SUBJECT: P&WC SERVICE BULLETIN (SB) No. 14499

P&WC S.B. No. 14499

TURBOPROP ENGINE
ELECTRICAL OIL-LEVEL FILLER-CAP AND INDICATOR - INSPECTION/REPLACEMENT OF

PT6A-72-14499
Cover Sheet

electric oil-level filler-cap and indicator
Figure 1

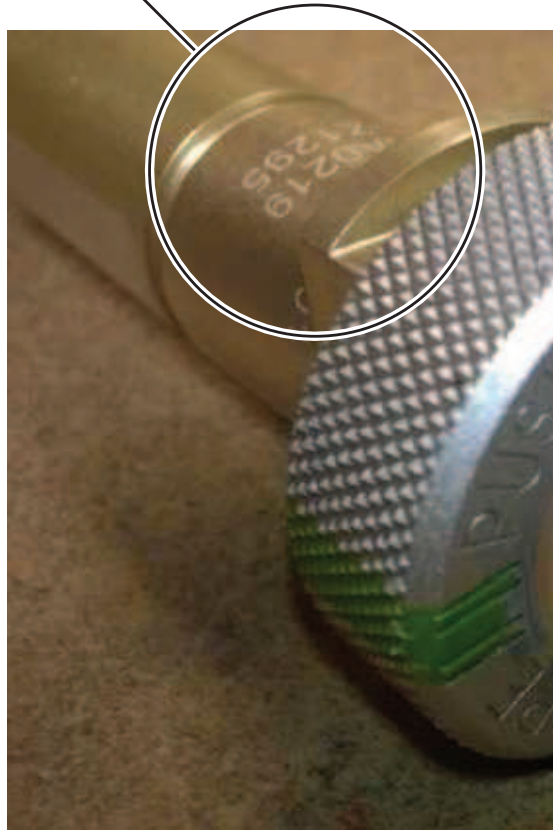
Verify if electric oil-level filler-cap and indicator serial number is within serial number range listed in Table 1. Refer to Figure 1 for location of electric oil-level filler-cap and indicator serial number.

- (1) If electric oil-level filler-cap and indicator serial number is within the identified range remove and replace with a new one.
